UNITED STATES PATENT AND TRADEMARK OFFICE

APPLICATION NO.	FILING DATE	FIRST NAMED INVENTOR	ATTORNEY DOCKET NO.	CONFIRMATION NO.
10/550,404	09/21/2005	Les Teichner	018044.01US2	2285
25541 7590 01/26/2009 NEAL, GERBER, & EISENBERG SUITE 2200 2 NORTH LASALLE STREET CHICAGO, IL 60602				
EXAMINER HOLLOWAY, JASON R				
ART UNIT 3633		PAPER NUMBER		
MAIL DATE 01/26/2009		DELIVERY MODE PAPER

Office Action Summary

DETAILED ACTION

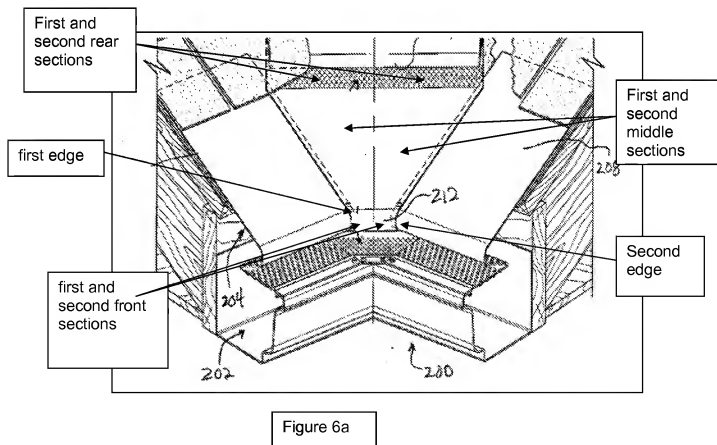
Regarding claim 5, Richard teaches the bracket further comprises a front member (front rafter 39), a base member (as labeled in examiner amended figure 12a following this action), an intermediate member (as labeled in figure 12a), a rear member (as labeled in figure 12a) and a central wall portion (as labeled in figure 12a), wherein

the coupling member (inwardly curved end 34) is integral to and extends from the intermediate member (as illustrated in figures 6-7, 10-12 and labeled in figure 12a coupling member 34 is integral to the intermediate member).

a base member having a first side and a second side (as labeled in figure 12a);

a central wall portion (as labeled in figure 12a) integrally formed from the base member, the front member and the rear member (front, base and rear members as labeled in figure 12a) and positioned between the front member and the rear member (as illustrated in figures 10 and 12a);

an intermediate member (of figure 12a) integrally formed on the front member, the central wall portion and the rear member, wherein the coupling member (34) is

integral to and extends from the intermediate member (as illustrated in figures 6-7 and 10-12, coupling member 34 is integral to the intermediate member, as labeled in figure 12a).

Regarding claim 8, Richard teaches the central wall portion (as labeled in figure 12a) comprises at least one aperture (as illustrated in figures 6, 7, 10-12 and 12a, rear and front rafter 37 and 39 comprise an aperture between them).

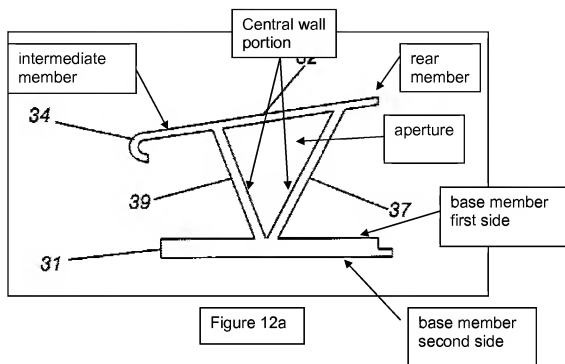
Seise teaches a corner piece for connecting two gutter covers (roofline segments 206 and 208 of cover assembly 204) having a first and second half having a first and second front section, a first and second middle section, a first and second rear section

and a first and second edge (first and second members are labeled in examiner amended figure 6a following this action), wherein the first and second front sections are capable of engaging and cooperating with the lip section (as illustrated in figure 6 and 6a, the front sections cooperate with the equivalent lip sections of the gutter covers of Seise), and wherein the first and second edges form first and second channels capable of receiving an edge of the first and second gutter covers (a channel is formed in the first and second front sections of the mullion which accepts the edges of the gutter covers); and

wherein the first half and the second half are joined at an angle relative to one another (as illustrated in figures 6 and 6a, the first and second halves are joined at an angle); and

wherein the corner mullion is positioned between the two gutter covers (cover assembly 204), which are adjacent and at an angled relation to one another (as illustrated in figures 6 and 6a, the two gutter covers are adjacent to one another).
